San Francisco Bay Conservation and Development Commission

SUBJECT: Draft Environmental Assessment/Environmental Impact Report: San Francisco Bay Federal Channels Operation and Maintenance Dredging and Sediment Placement Activities, Dredging Years 2025-2034

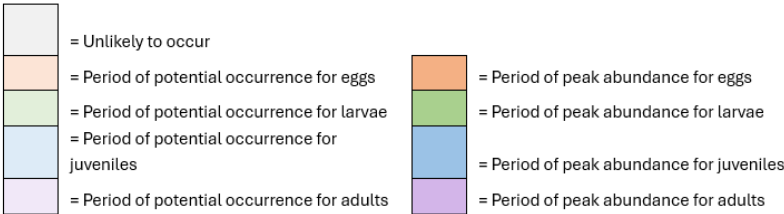
While the Commission absolutely supports increasing beneficial reuse and recognizes the connection between smelt and tidal channels of wetlands and restoring marshes, clarity is needed in these descriptions. It is important to be clear in language. Increasing beneficial reuse of dredged sediment does not minimize impacts from hopper dredges. Per the Draft EA/EIR, hopper dredging increases entrainment over clamshell dredging.

Increasing hopper dredging increases impacts to listed and native fish. Beneficial reuse may be considered a form of mitigation for this impact, but it is not a minimization measure.

RECOMMENDATION: Provide analysis of potential entrainment of longfin smelt based on the entrainment data that currently exists. Include the above table and information regarding the use of the estuary by longfin smelt rather than just a percentage of habitat used, which is unknown at this time. Acknowledge that these measures are experiment and that other species may be affected by deterrent methods. If these measures are used, commit to an open and transparent process with the regulatory and resource agencies and include an analysis of potential effects to other species.
